# UNITED STATES PATENT AND TRADEMARK OFFICE

APPLICATION NO.	FILING DATE	FIRST NAMED INVENTOR	ATTORNEY DOCKET NO.	CONFIRMATION NO.
10/603,450	06/24/2003	Ernest B. Pryor JR.	10499-649US (795210104-03)	4405
570	7590	08/10/2005	EXAMINER	
AKIN GUMP STRAUSS HAUER & FELD L.L.P. ONE COMMERCE SQUARE 2005 MARKET STREET, SUITE 2200 PHILADELPHIA, PA 19103			SOOHOO, TONY GLEN	
			ART UNIT	PAPER NUMBER
			1723

**Office Action Summary**

## **DETAILED ACTION**

FIG. 3

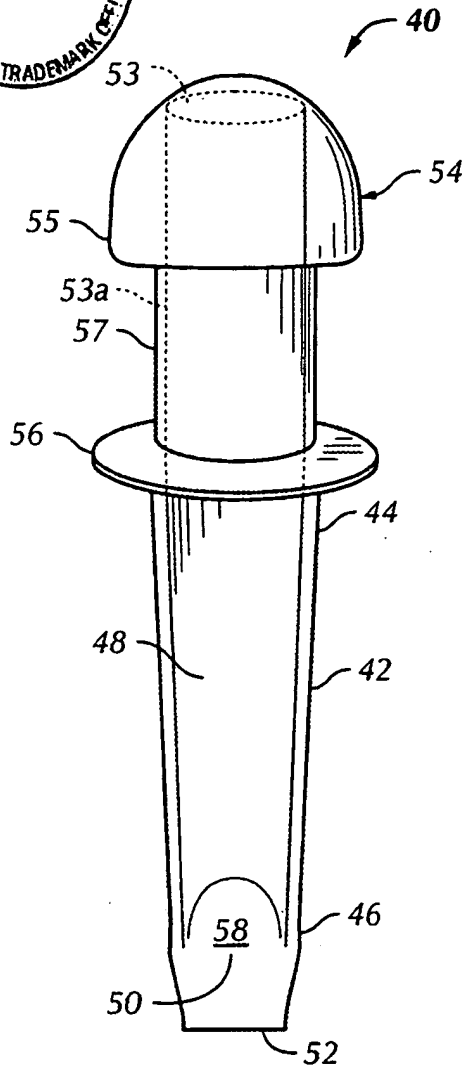
1. The drawings were received on 5-19-2005. These drawings are NOT APPROVED. The drawings introduce new matter to the showing of the relative position of the handle opening through the handle itself, in a longitudinal manner along the handle and upon both element of figures the embodiments of fig 3 and fig 6. Basis is only for the handle having an opening in communication with the cavity, but falls short of a enablement of the opening through the handle itself.

Not  
Approved  
TGS 8-8-05  
TONY G. SOOHOO  
PRIMARY EXAMINER

Applicant is required to cancel the new matter in the reply to this Office Action.

FIG. 5

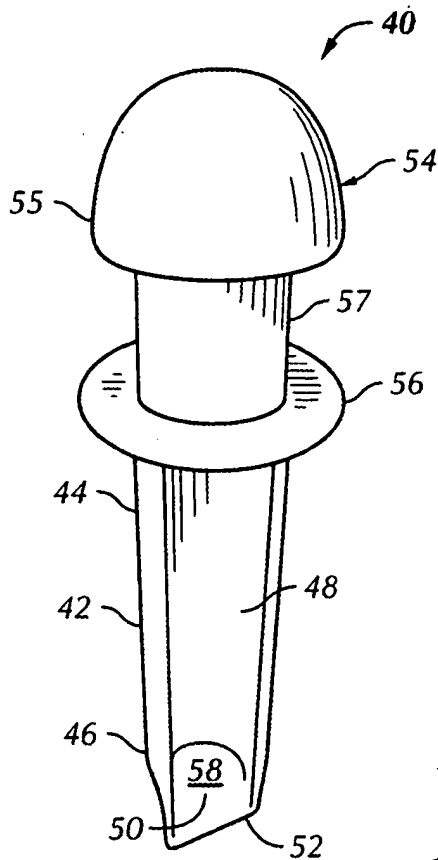
NOT  
APPROVED  
TO 8-8-05
